8 June 2018

Attn: Dr Paul Vogel
Chairman
Northern Territory Environment Protection Authority
PO Box 3675
DARWIN NT 0801

Primary Gold Limited – Environment Impact Statement (EIS), 14A Amendment to the Toms Gully Underground Project Site - Modifications Reflective of the Environmental Studies Associated with the EIS Supplement Preparation (June 2018).

Figure 2: Modified Toms Gully Underground Project site layout (to be submitted as part of the EIS Supplement).

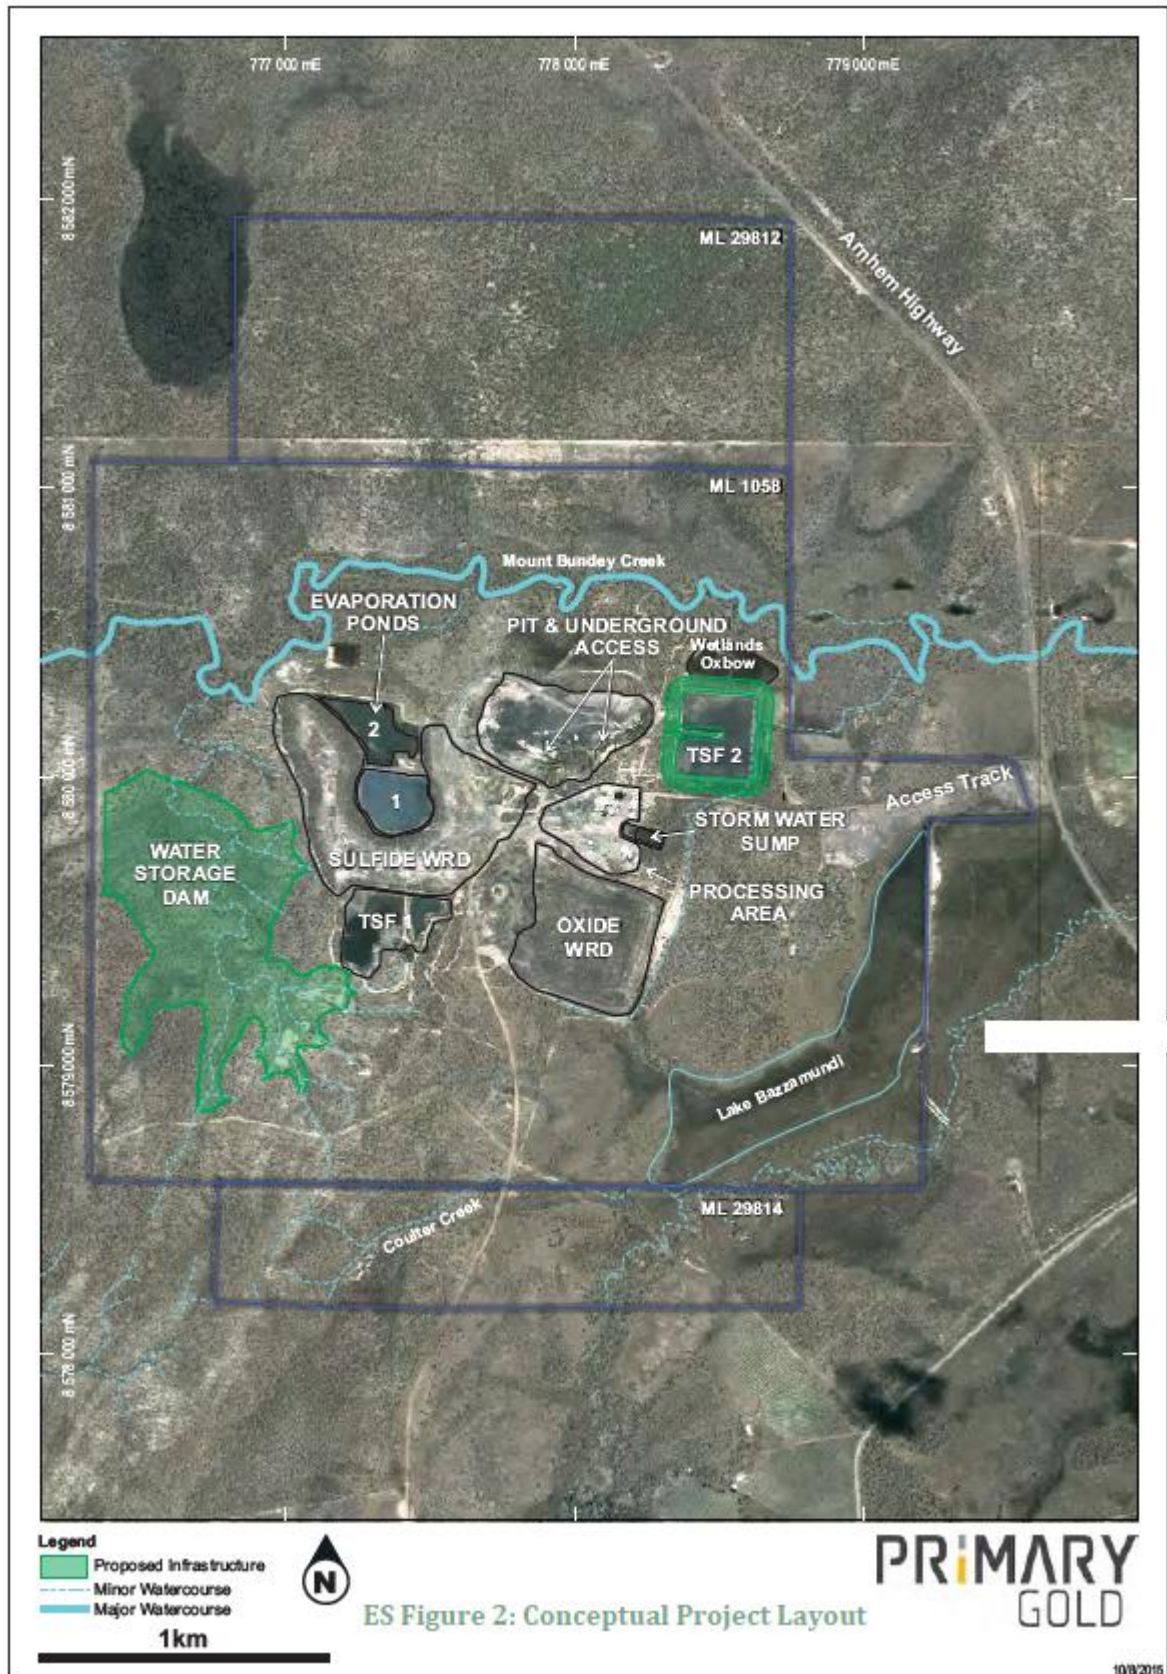
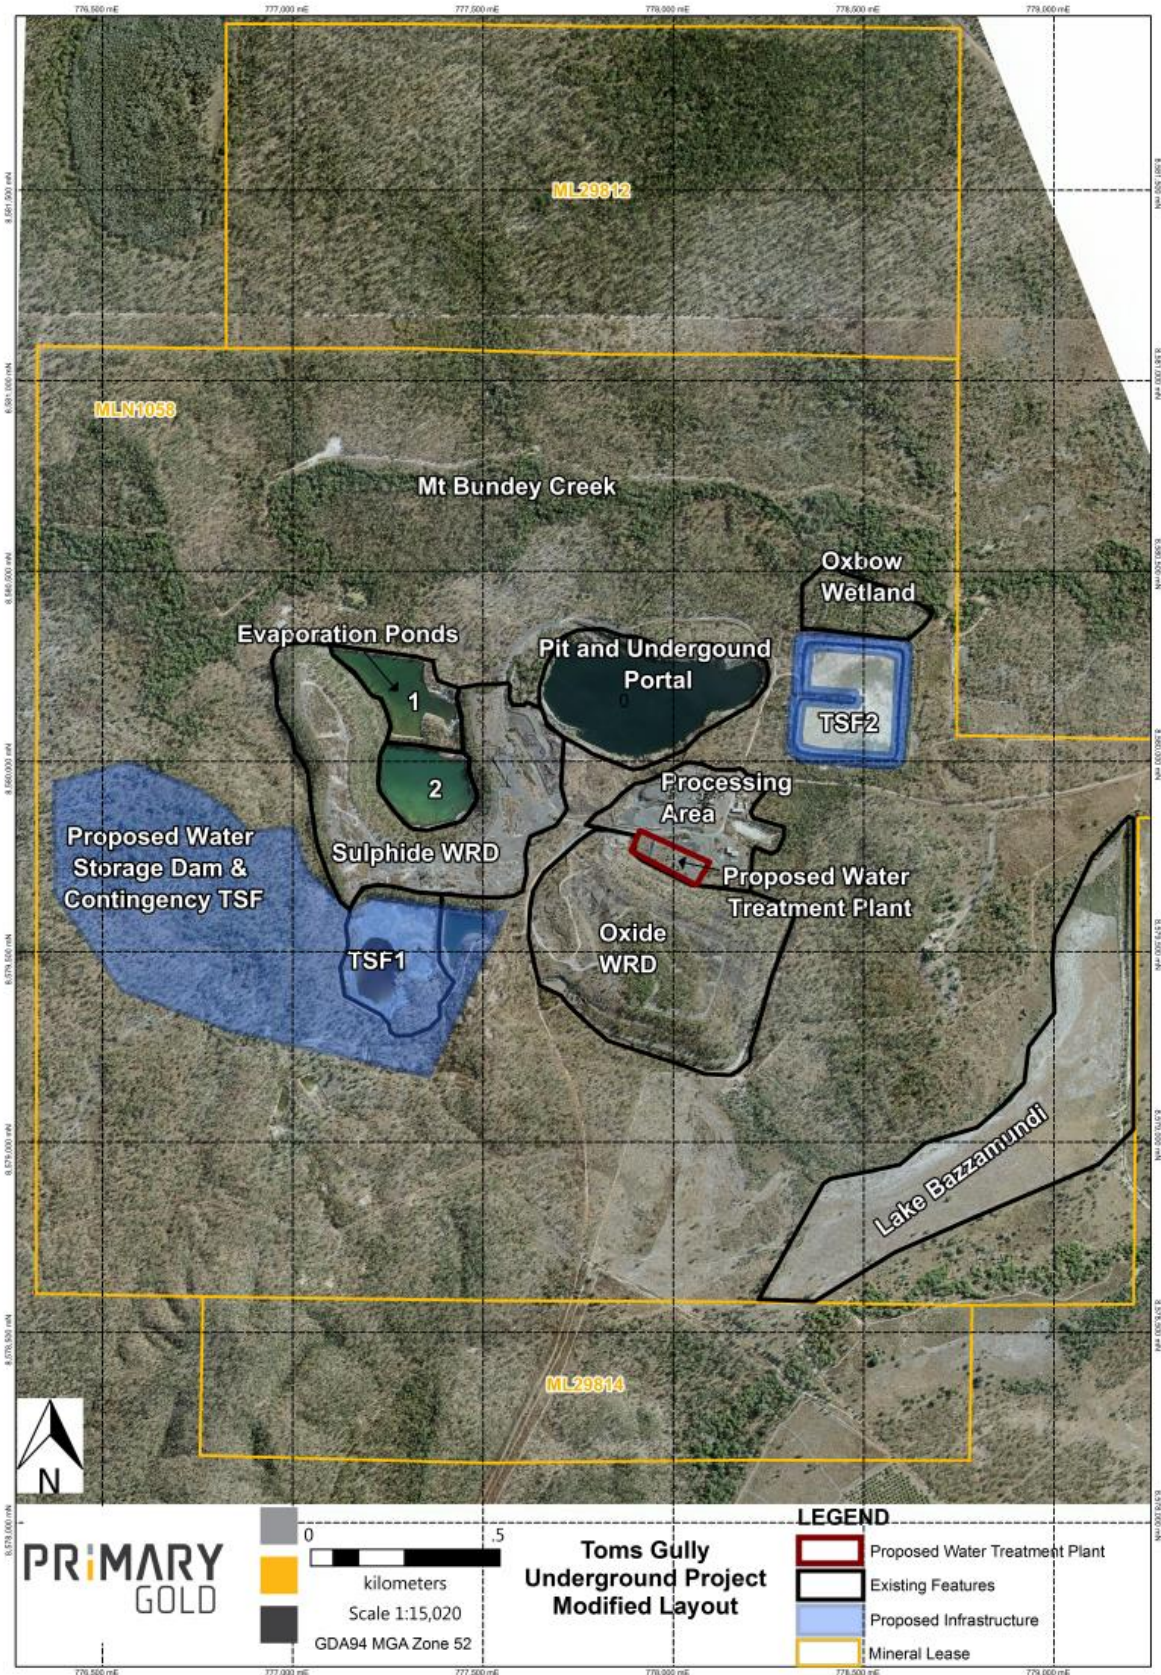
The proposed changes to the footprint of Toms Gully Underground Project are outlined in Figure 1 (original layout) and Figure 2 (revised layout).

1. Selection of a preferred water treatment option provided by Global Aquatica known as the Bioaqua Process. This will result in a standalone water treatment plant.
2. Additional use of the Bioaqua Process to process both existing and future tailings to extract gold, mixed metal oxides, sulfur and silica. Thus reducing tailings volumes and creating more benign tailings. This will result in the same standalone water treatment plant being used for tailings processing.
3. Proposal to reprocess tailings from TSF1 and TSF2 with an upgrade of both facilities to ANCOLD 2012 guidelines and lined if the nature of the tailings requires it (Option 1: preferred option).

4. The proposed contingency if Option 1 does not work (i.e. if either TSF1 and TSF2 cannot be reused) is to construct a purpose built tailings storage facility in accordance to ANCOLD 2012 guideline. If required, lined to reflect the nature of the tailings material (Option 1: contingency option). Location presented in Figure 2.
5. Replacement of the originally proposed valley Water Storage Dam 2.1 GL with a 1 GL embankment enclosed Water Storage Dam. Location presented in Figure 2.
6. Inclusion of topsoil stockpiles
7. Potentially changing from grid power to diesel generators.

Details of the location of the topsoil stockpiles will be within the green polygon contained in Figure 2. Locations for the topsoil stockpiles are selected to:

Figure 3: Preliminary Conceptual AMD Model with the effect of the Amendments (Reproduced from pg 43 Appendix A of Appendix 11 within the Draft EIS).

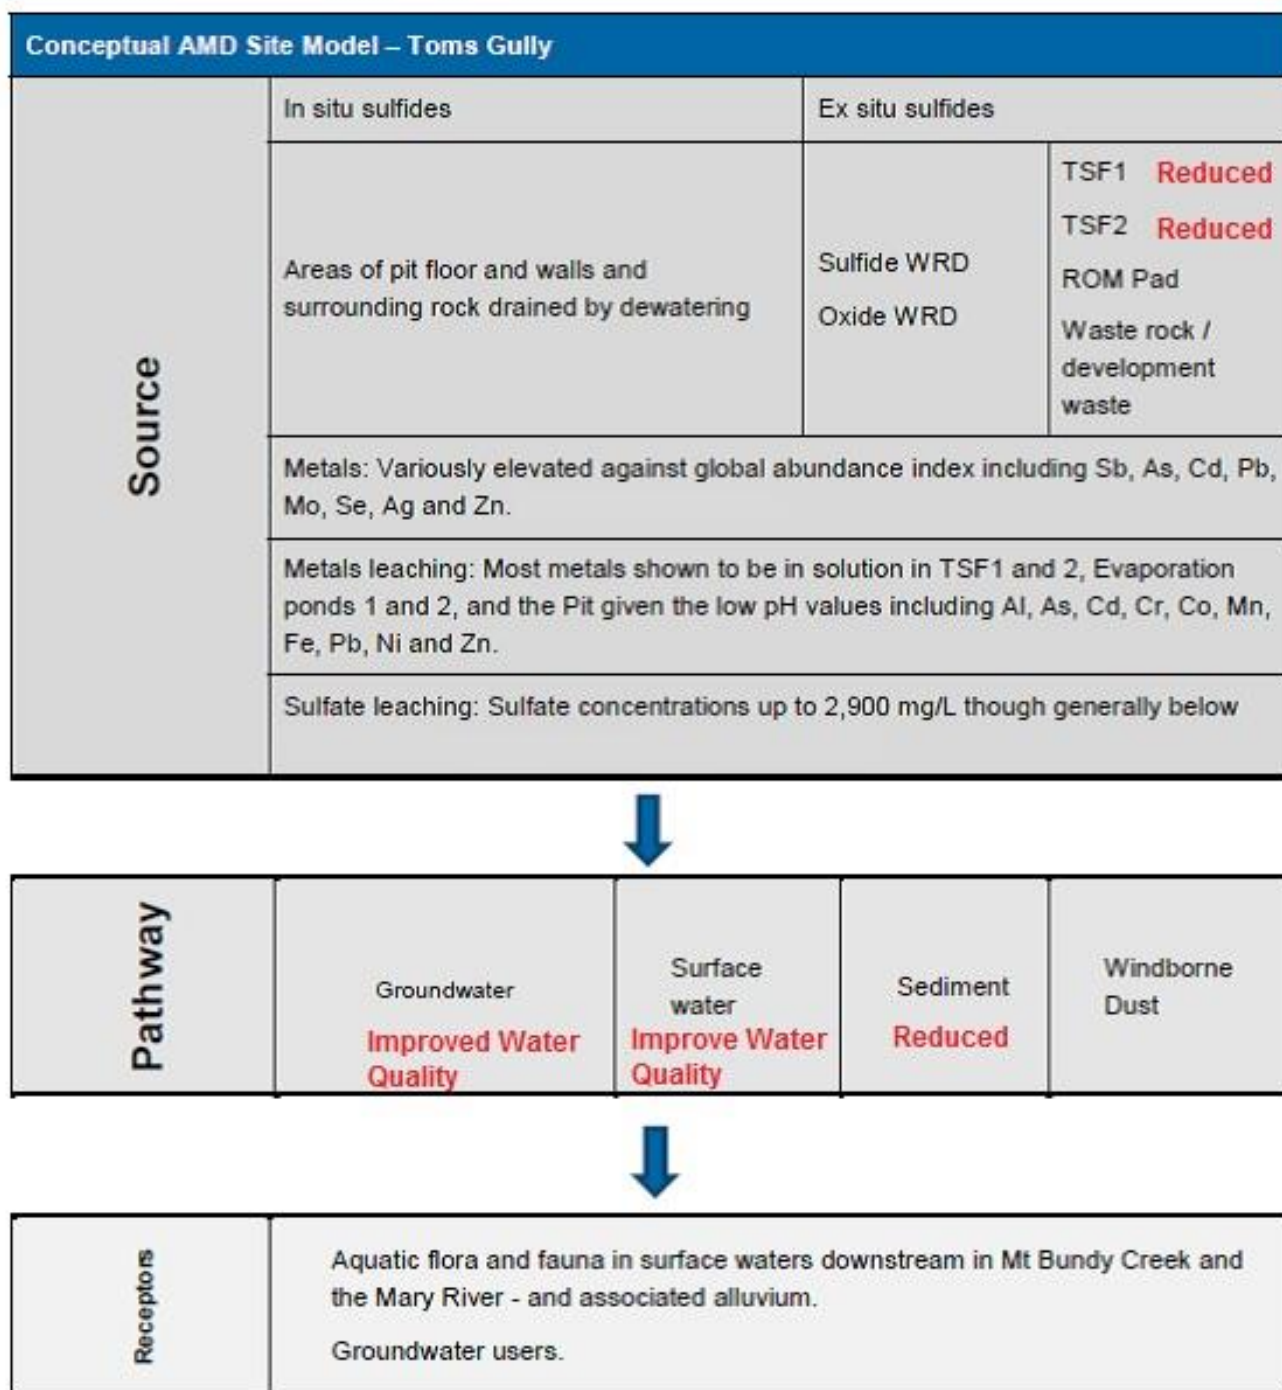
To understand the potential impacts associated with the proposed alterations, the changes need to be considered in the context of a source – pathway – receptor model for the site. Figure 3 summarises the changes in to the Preliminary Conceptual Site Model that was presented in the Draft EIS. Table 3 provides details on the changes to the environmental characteristics as a result of the proposed changes.
